Model: AC Top Drives Serial #: N/A	Mar. 28, 2014
Product Bulletin # TDS-139

PanelView Unit Replacement (Standalone Top Drive System)

Figure 1: PanelView 1000

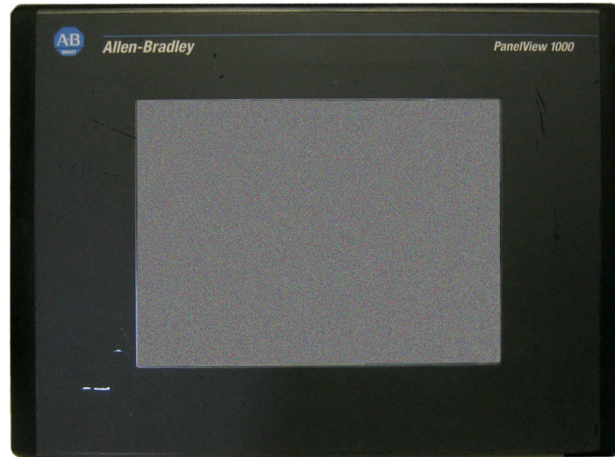
3. What color is the bezel of the existing PanelView unit?
 - a. Black (labeled PanelView 1000). See Figure 1 below.

When replacing a PanelView 1000 order the following parts:

Qty	Part Number	Description
1	E11409	Power Supply 24 VDC
1	E11337	DIN Rail, 4"
2	RH-P-10-32-0050-SS	10-32 Screws
2	LW-10-ET-SS	Lock Washers
2	E16-1102-010	End Brackets
2	LN-10-32	Lock Nuts

Figure 2: PanelView Plus 1250

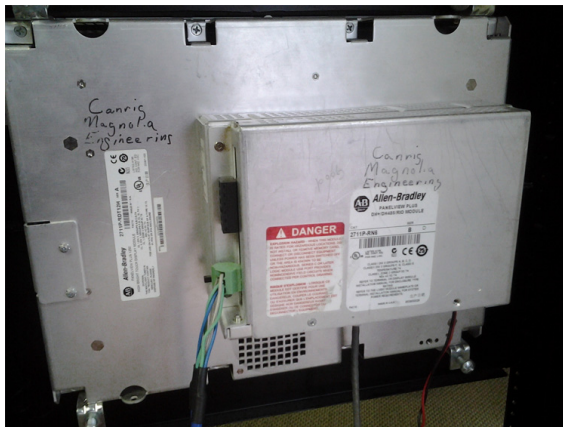
b. Gray (labeled PanelView Plus 1250). See Figure 2 below.

If the existing unit is a PanelView Plus 1250 (display on the left on Figure 3) continue to “Identifying Installed Processor” on page 4.

If the existing unit is a PanelView Plus 6 1250, part number AY18938 (display on the right on Figure 3) the procedure is complete. No additional parts are required.

Figure 5: Procedure Flowchart

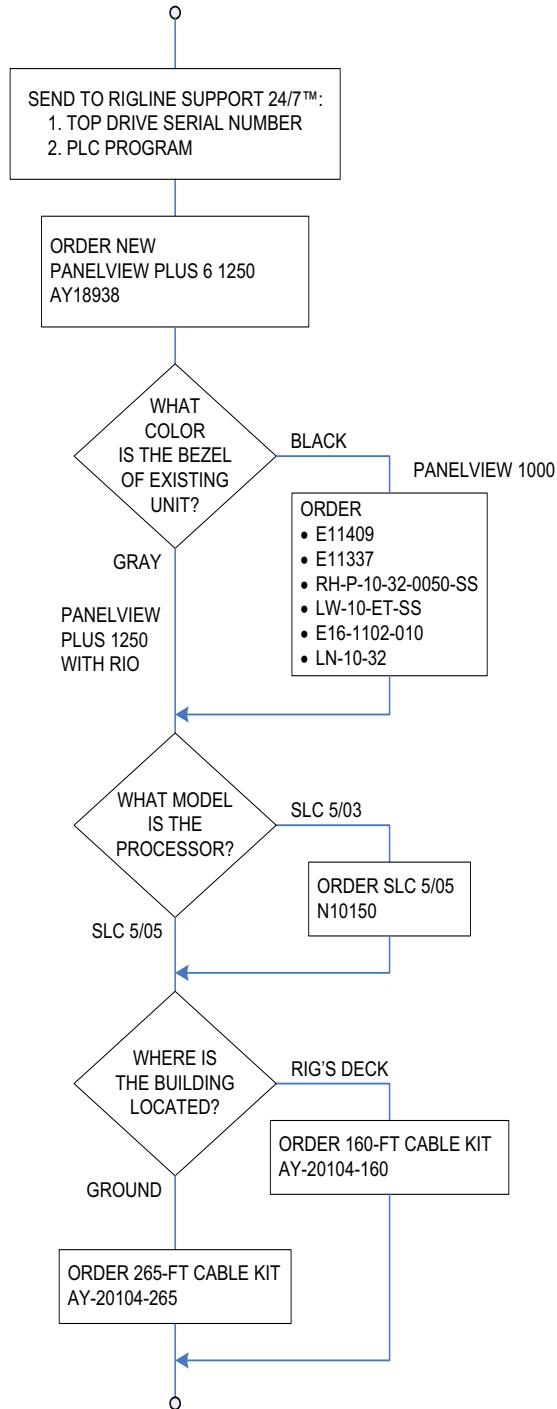
Damaged units used in a standalone top drive must be upgraded to the more recent PanelView Plus 6 1250 model. Follow the steps below to identify the existing unit and select the parts required to complete the upgrade.

Refer to the diagram on Figure 5 on page 6 for additional information.
